**Subject: DEVIATION REVIEW AND DECISION FORM**

Subdivision or Project Name: The Gardens at North Carefree Final Plat

Section of ECM from Which Deviation is Sought: SECTION 2.3.4, TABLE 2-14  
Specific Criteria from Which a Deviation is Sought: RATE OF VERTICAL CURVE, K

**THE GARDENS AT NORTH CAREFREE  
PLAN AND PROFILE  
FALLOW LANE & RUNNING DEER WAY**

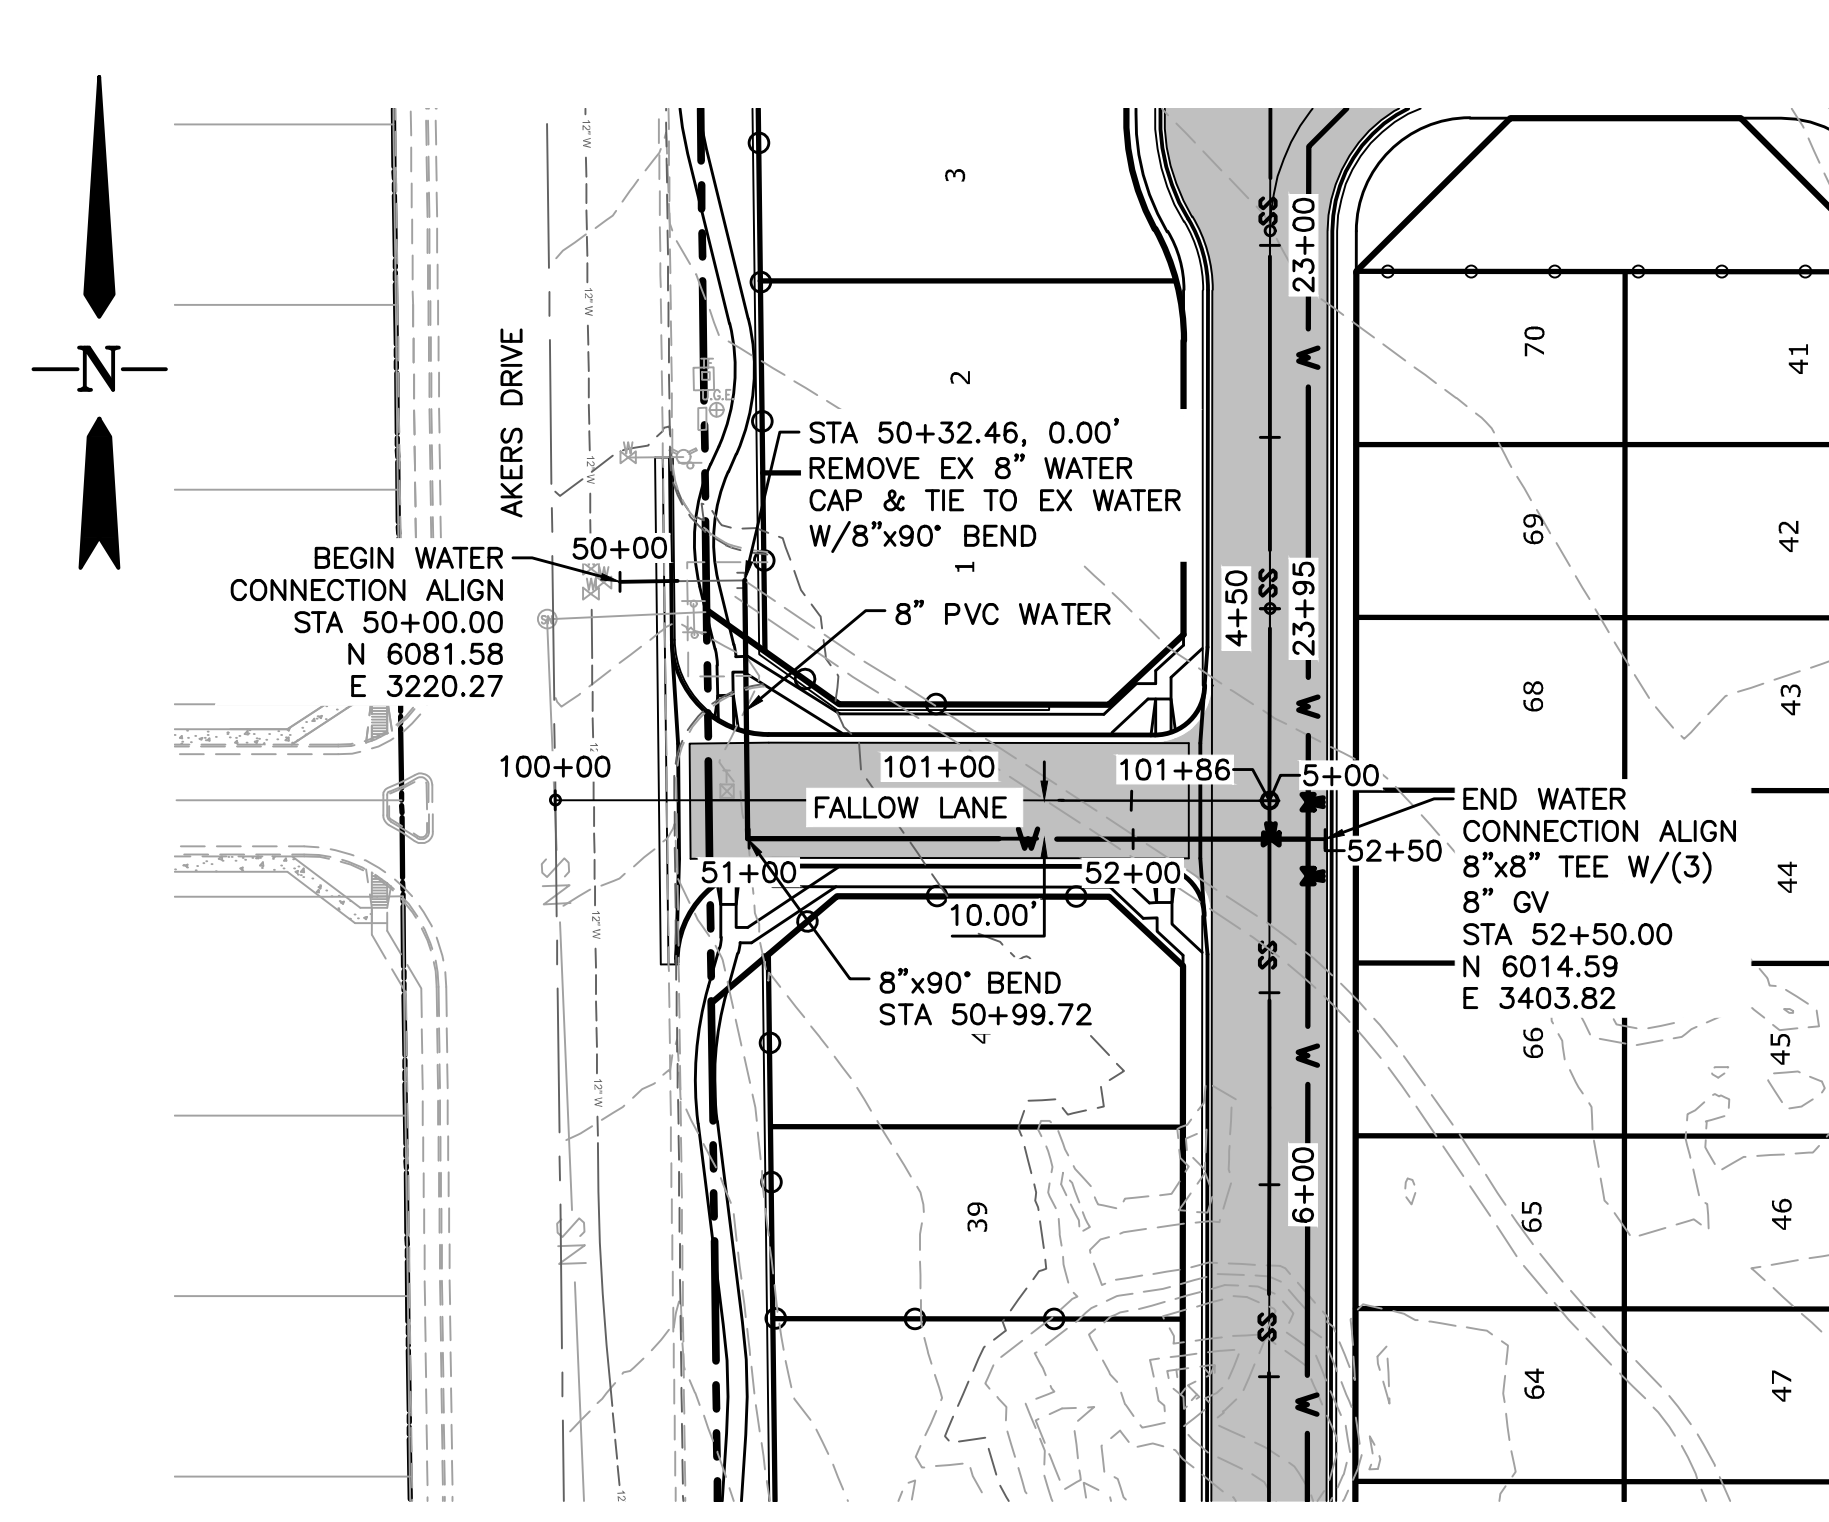
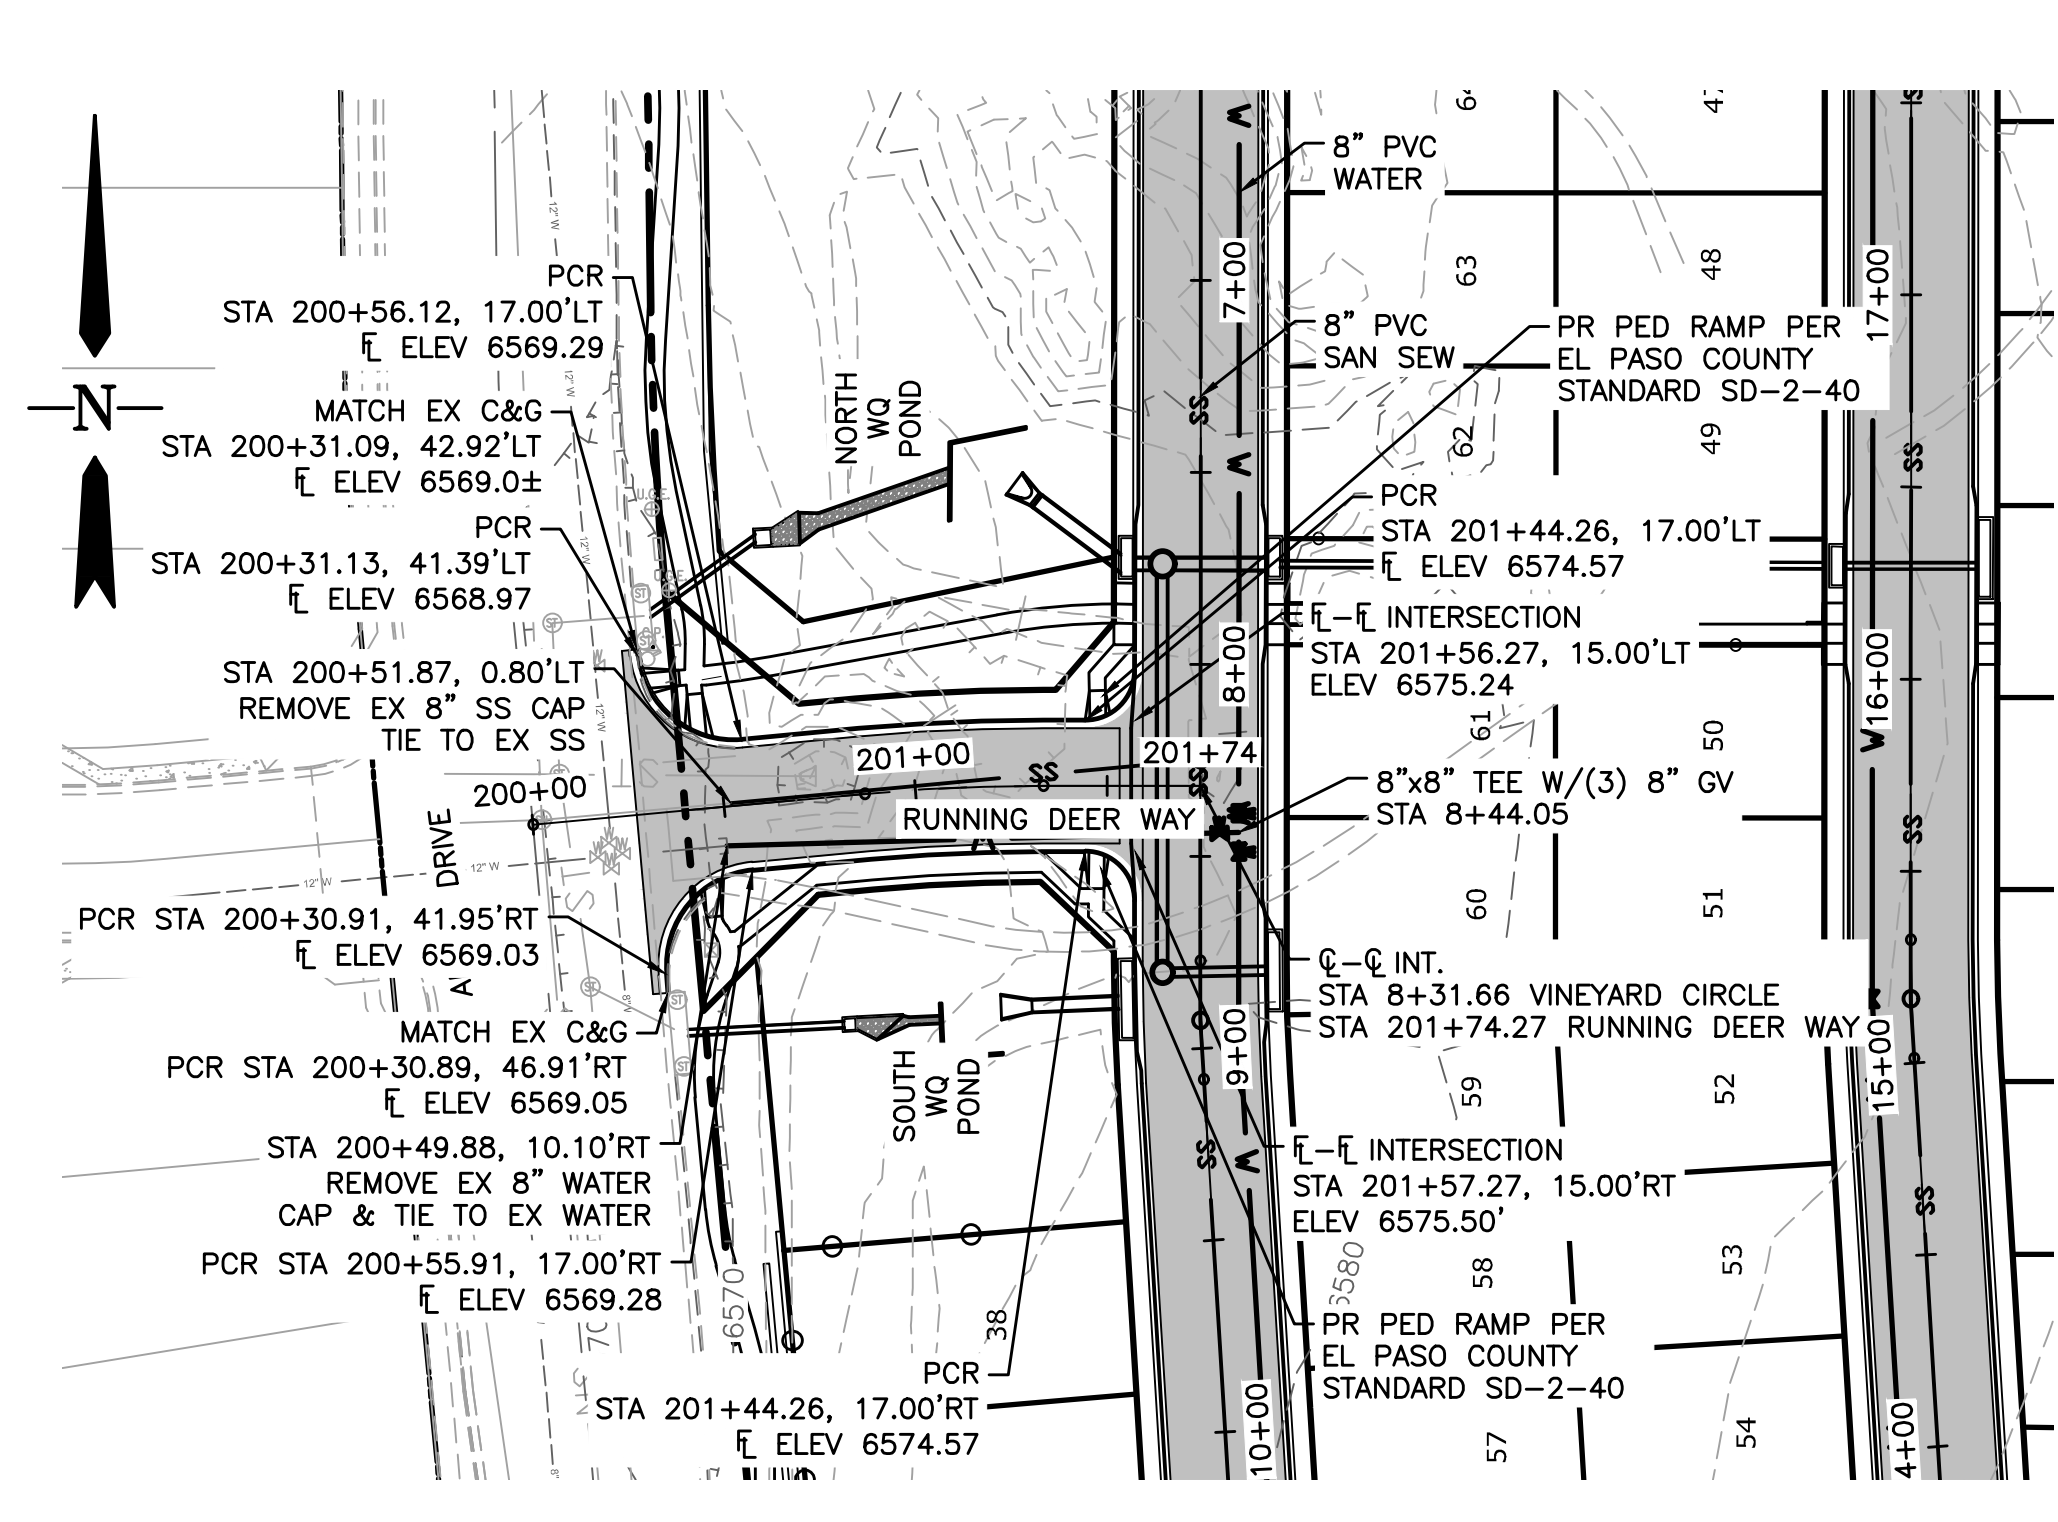
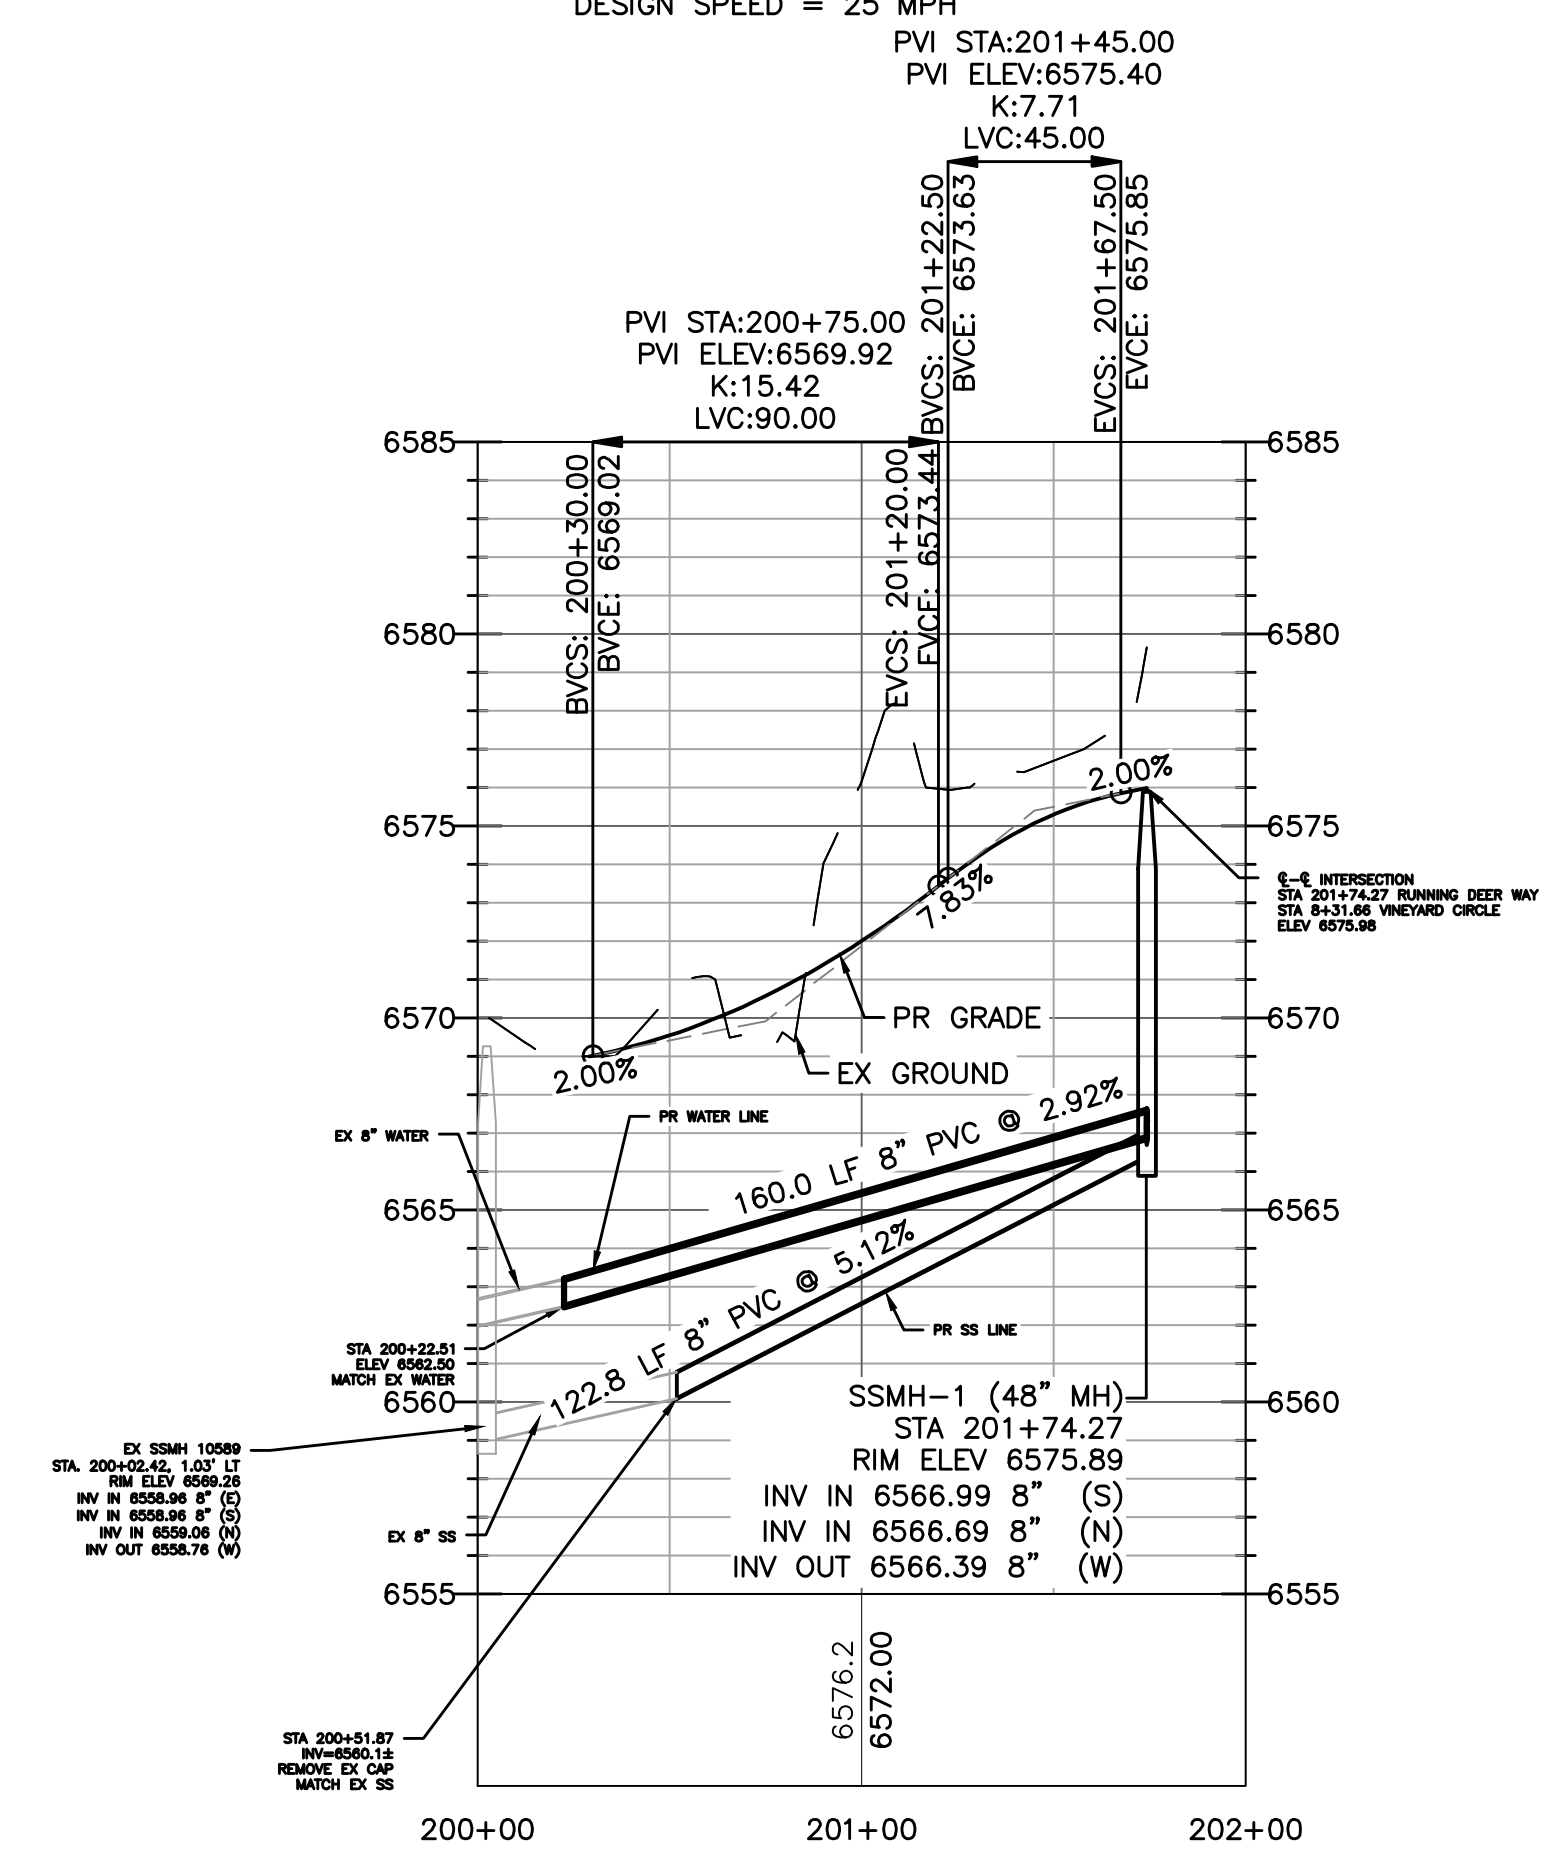
Please indicate the roadway that each of the K values is associated with.

and table 2-12

Refer to comment on drainage report & plan and revise as necessary.

i think you meant maximum

please state that the deviation is not based on financial consideration.

Proposed Nature and Extent of Deviation: The 2 access roads to the project (Running Deer Way and Fallow Lane) cannot meet the minimum K value requirements for vertical curves in part to the short segment of each road and driven by the requirement to treat 100% of storm water on site and the requirement to provide a 2% cross slope at the intersection with Akers Drive to meet ADA standards for cross walks. The K factors being used are 9.5 and 7.71 at the crest and 15.42 in the sag; required K factor are 12 at the crest and 26 in the sag curves. Access is only allowed to Akers Drive

The access drives have been designed at maximum allowable slopes to intersect with Akers Drive, pushing the high point in these drives as close to Akers Drive as roadway criteria will allow reducing the amount of roadway area to the minimum of 0.19 acres that does not drain to the detention ponds on site. This is the minimum area allowed to not drain to a pond based on the previously approved water quality deviation.
